## Department of Transportation

#### MEMORANDUM

**SUBJECT:** ZC Case No. 23-24 – 1708-1710 First Street NE (Eckington Mews PUD)

**Figure 1 | Site Plan**

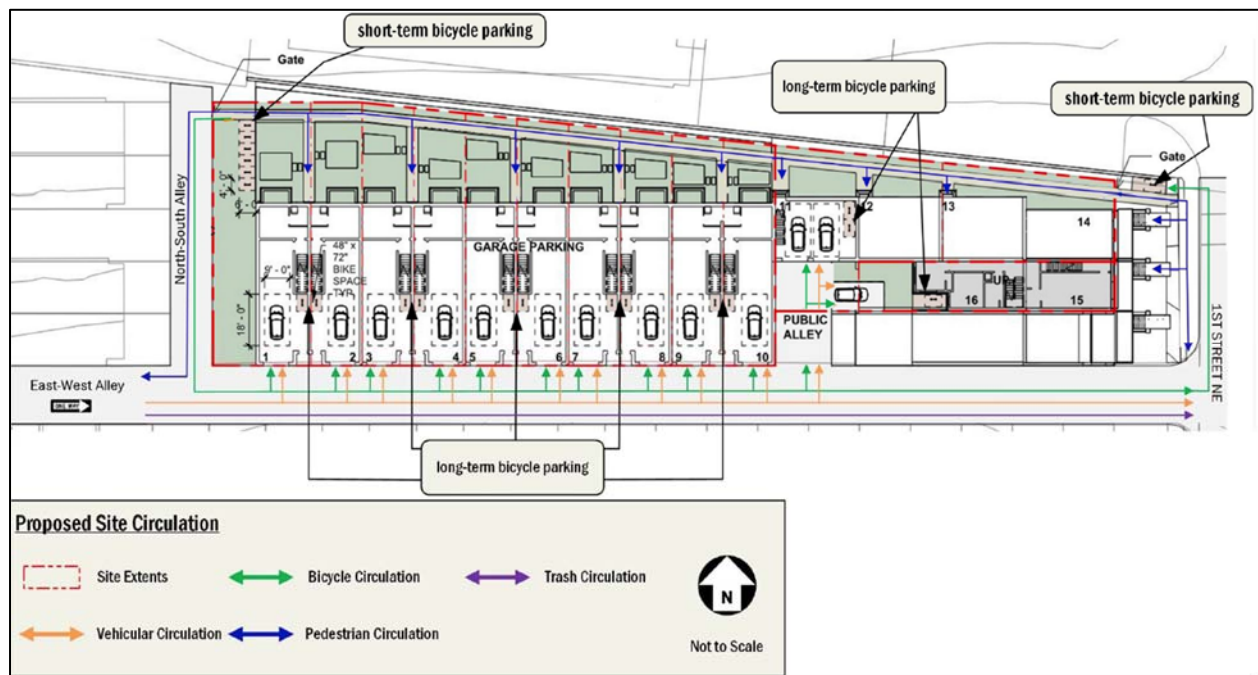
While the preliminary public space plans, shown above in Figure 1, are generally consistent with DDOT standards, there are several considerations that need to be reviewed in greater detail during the public space permitting process:

- Continue to coordinate with DDOT about the Applicant's proposed traffic calming measures within public space.
- All vehicular site access to the site, as well as trash pick-up, must be via the existing rear public alley network. The closest alley entrance is from Lincoln Road NE;
- Submit a detailed curbside management plan with proposed signage for review and approval by DDOT Curbside Management Division (CMD);
- Determine a final location for the inverted-U bicycle racks in public space, with preferably at least one (1) U-rack moved from the rear of the site to the site's First Street NE frontage; and

**Figure 4 | Existing Pedestrian Network**

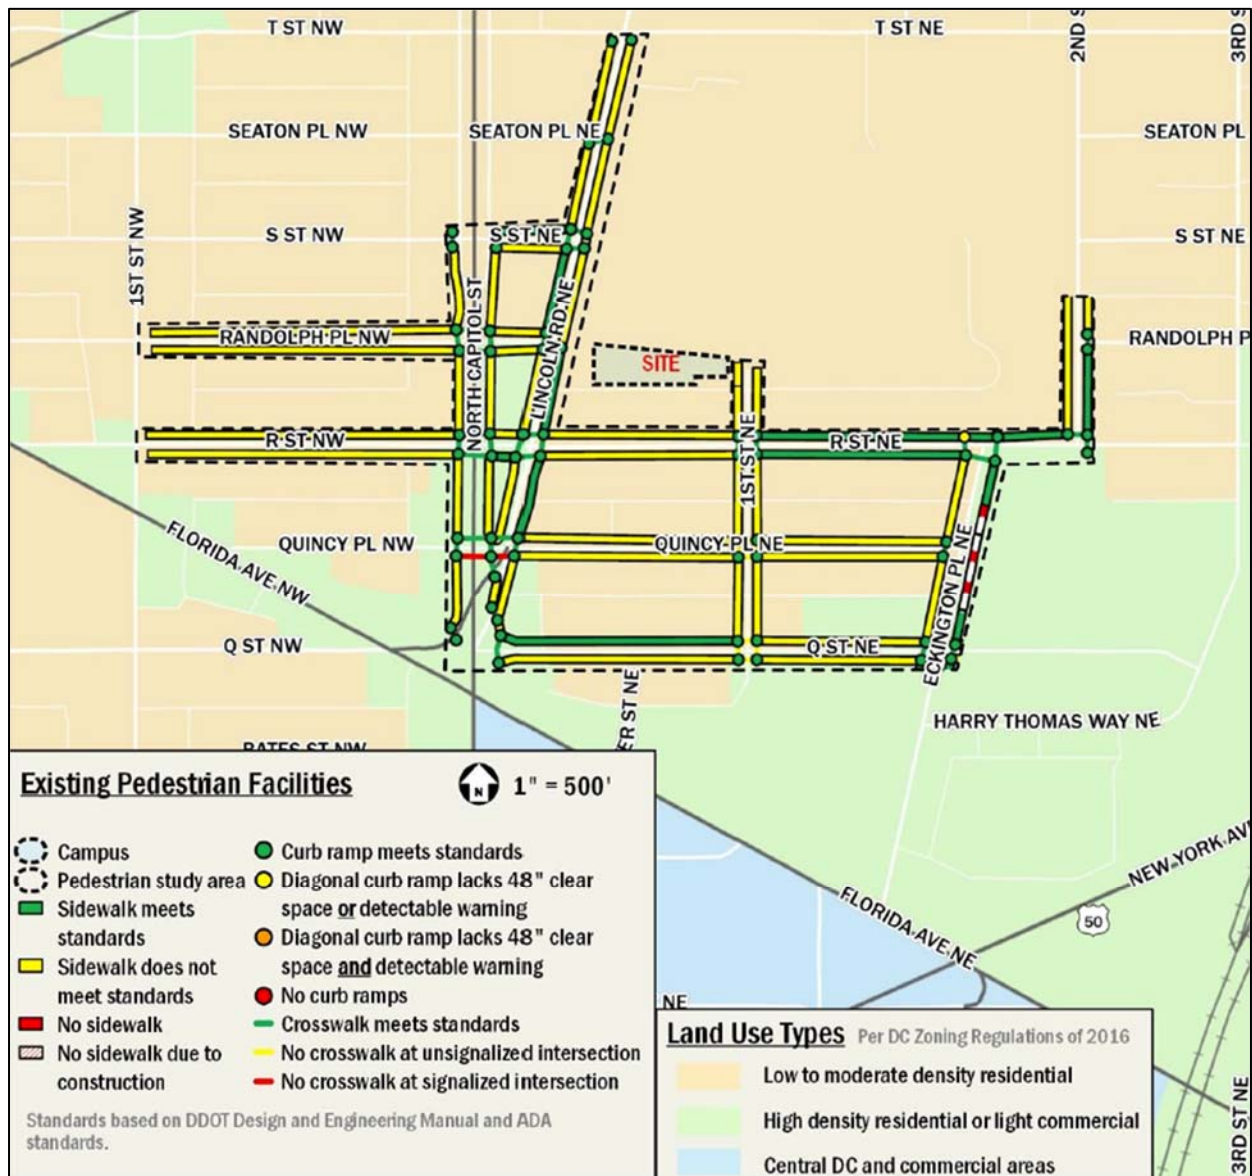
The Transportation Statement’s inventory of existing pedestrian infrastructure, as shown in Figure 4 below, demonstrates that while there are several substandard facilities in the vicinity of the site, most facilities that are substandard still provide an unobstructed clear width of at least five (5) to six (6) feet even if they do not provide sufficient buffer width. Most also include accessible curb ramps. Despite

these substandard facilities, the existing pedestrian network along major walking routes from the site to schools, attractions, and the Metrorail station is generally acceptable.
